**From:** [David Hay](#)  
**To:** [Mark Ross](#)  
**Subject:** Pohuehue Rd - Response to Council Comments on S92 Response.  
**Date:** Friday, 31 October 2025 2:11:46 pm  
**Attachments:** [image001.png](#)  
[image002.png](#)  
[image003.png](#)  
[image004.png](#)  
[image005.png](#)  
[image006.png](#)  
[image007.png](#)  
[image008.png](#)  
[Second Engineering RFI Response + Updated Plans.pdf](#)

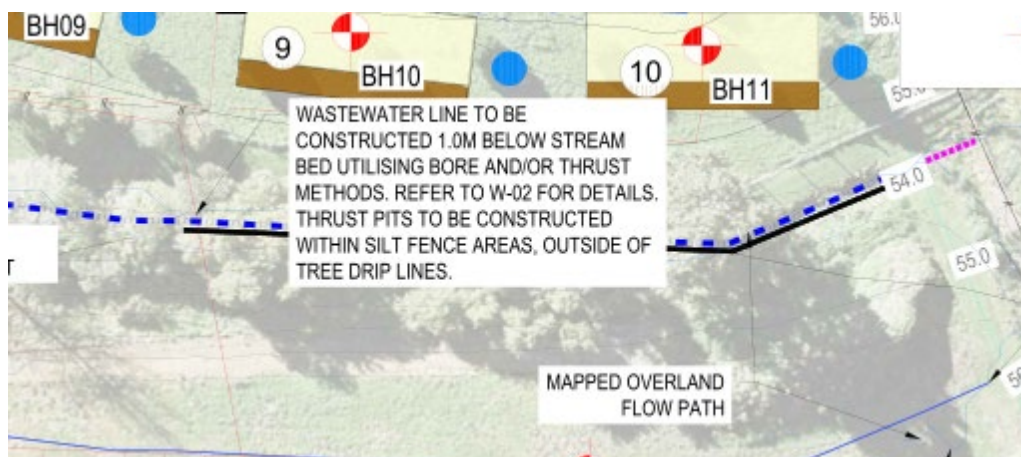
In respect to Q9 and our earlier email exchange:

Q3 We identified that the wastewater line is going under the stream. This was clear on Sheet 10 but as noted above the note has been expanded so it is very clear.

To further assist Council we have provided a further updated Sheet 10 (included in the Engineering response) which now identifies that the installation of the wastewater line underneath the watercourse will be by trenching or thrusting. A snip of this is below.
